JOINT FEDERAL/STATE APPLICATION FOR THE ALTERATION OF ANY FLOODPLAIN, WATERWAY, TIDAL OR NONTIDAL WETLAND IN MARYLAND

USACE Comment	MDOT SHA Response
	The Corps appreciates the opportunity to comment on the Draft JPA for I495 MLS. We found files well organized and easy to access, and the mitigation tables were particularly helpful. After review, additional discussions are needed regarding details of impacts for some locations and opportunities for additional avoidance and minimization. Additional comments will be provided after receipt of the final JPA. Our six major comments are:	
	1 More detail is needed regarding bridge alternatives (Impacts, sequence of construction, etc.) regarding work at the American Legion Bridge. Some details are provided in Appendix G NPS SOF of the Draft EIS, and the Corps would like to discuss refined options in further detail. ALB impacts and approaches will be considered in review of the final JPA.	Please refer to the Avoidance, Minimization, and Impacts Report Section 2.2.1, included in the Revised JPA package for a more comprehensive summary of the alignments considered in the vicinity of the ALB. Sequence of constructions and design details are no

Mainline Impact Plate 17

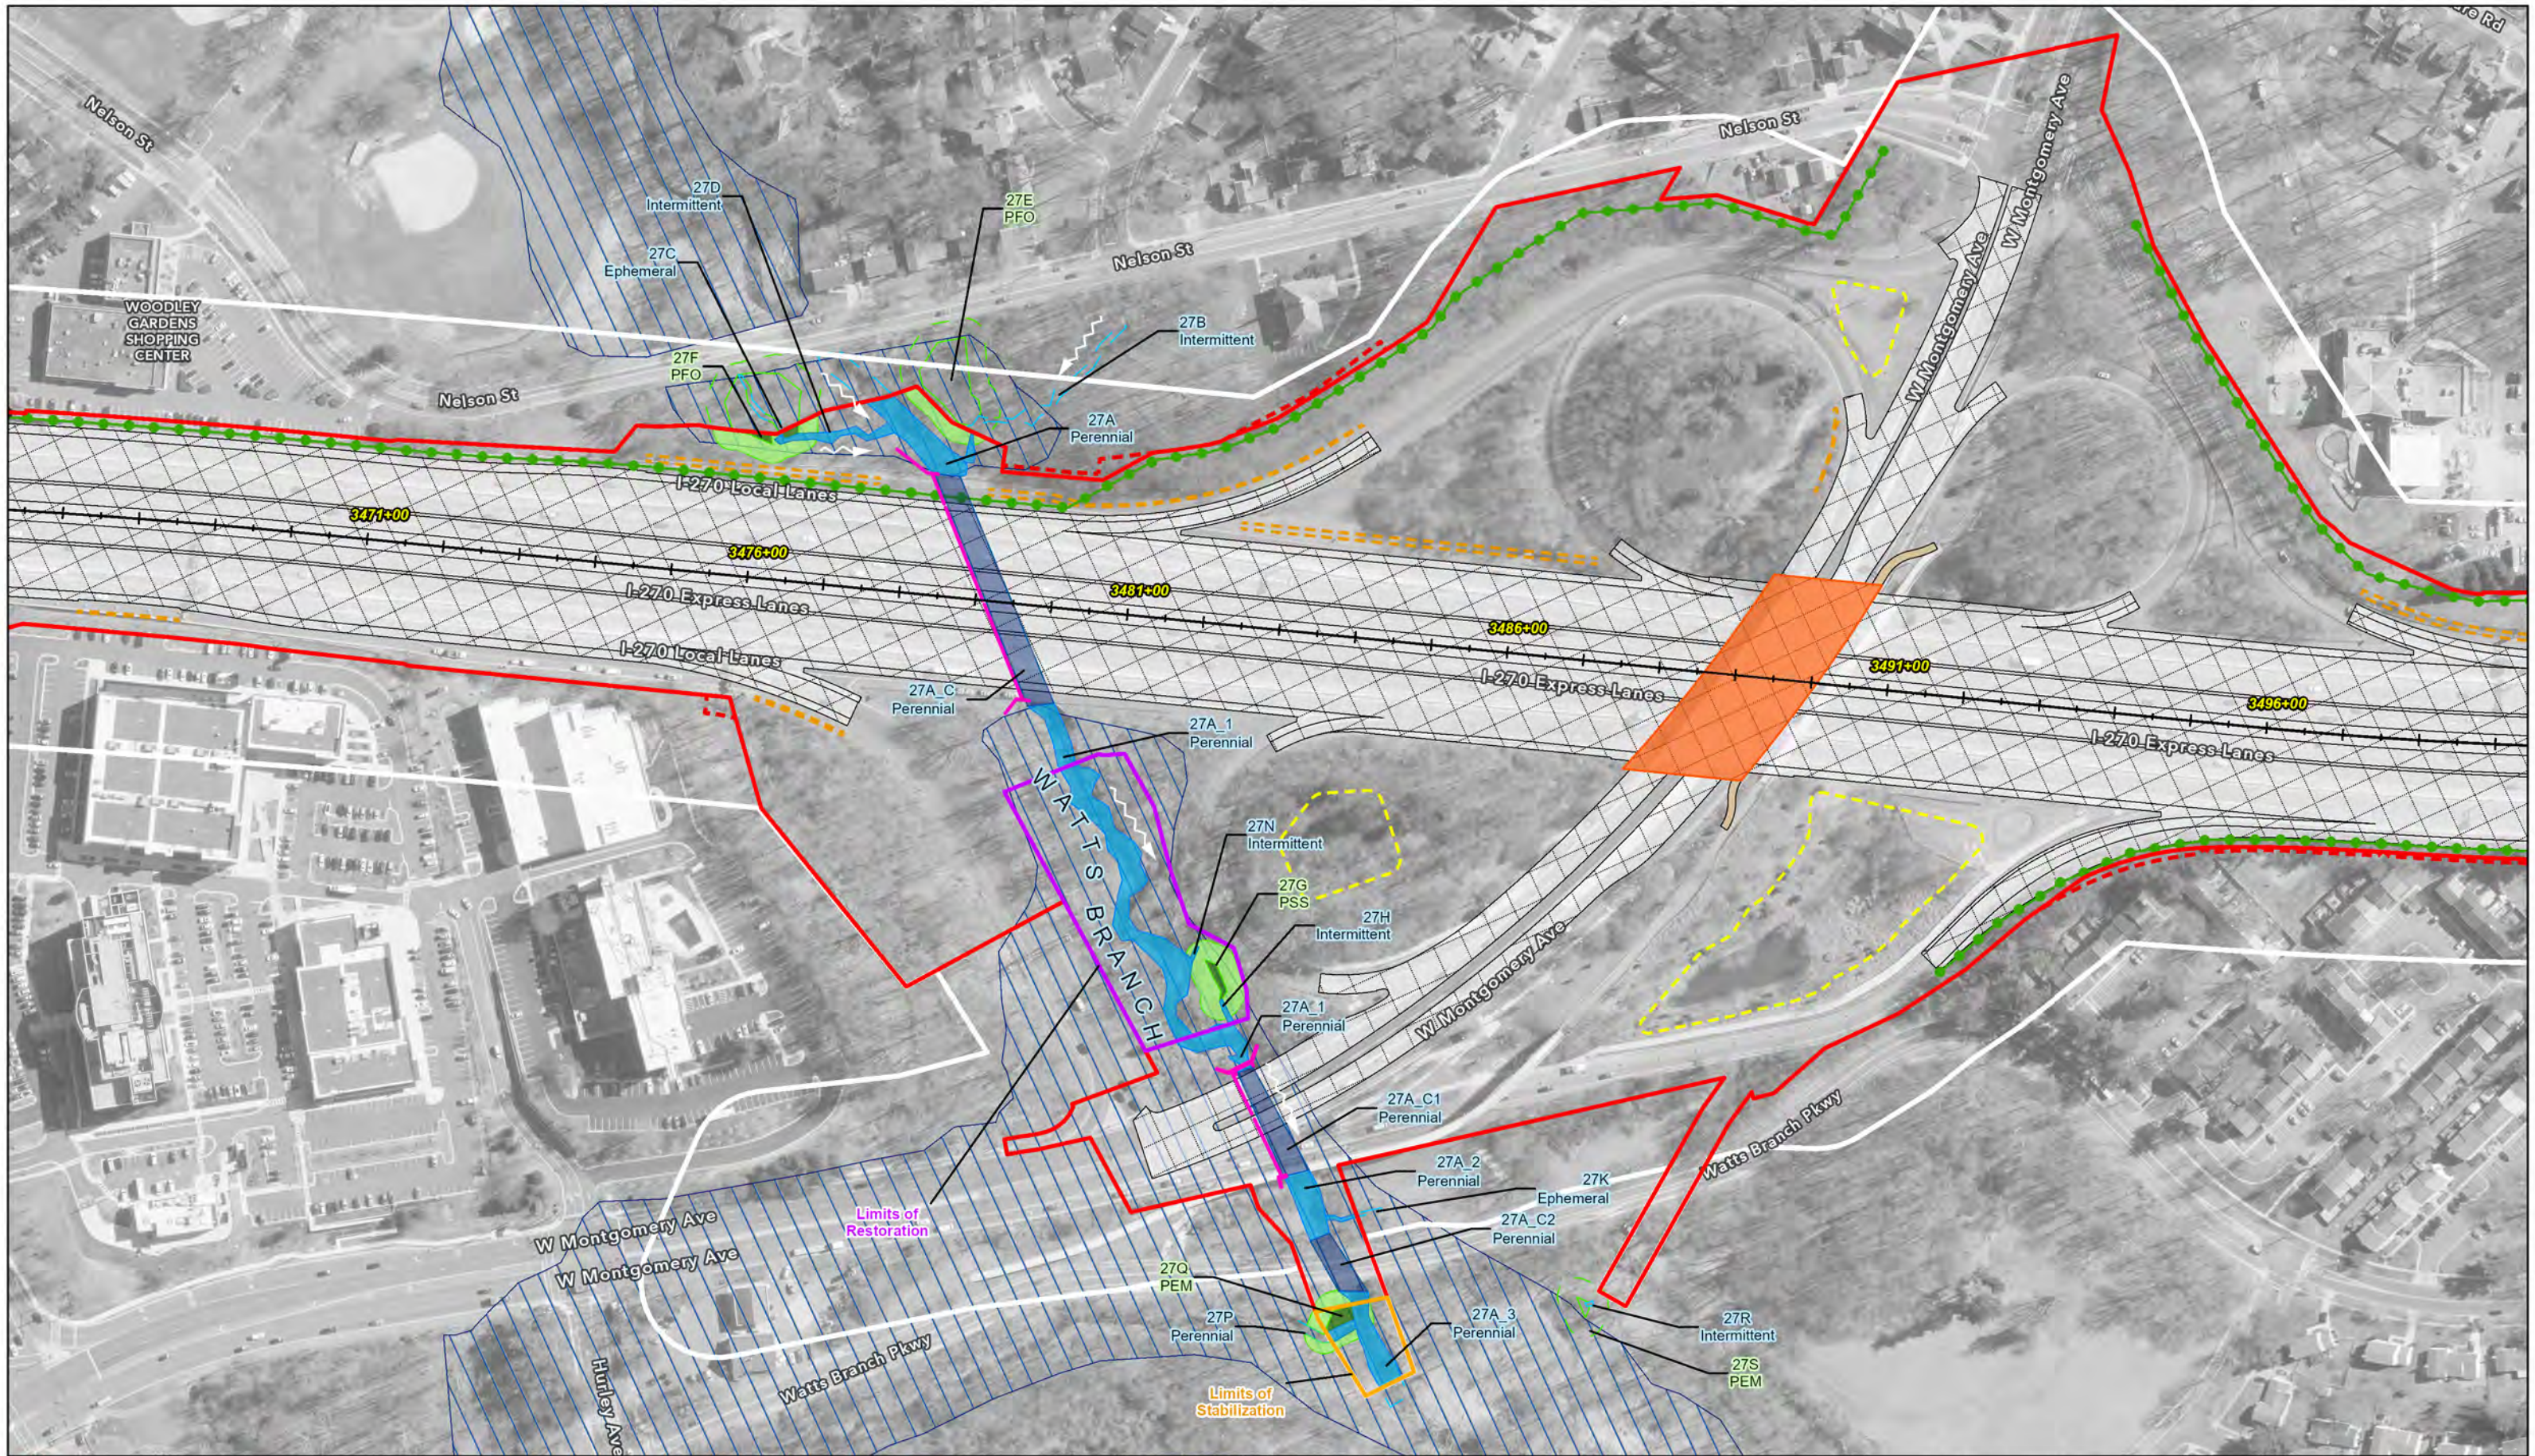
19	Impact Plate 17	Please change the classification label for 26A to PFO, as shown in the Wetland Delineation Memo.	Revised.
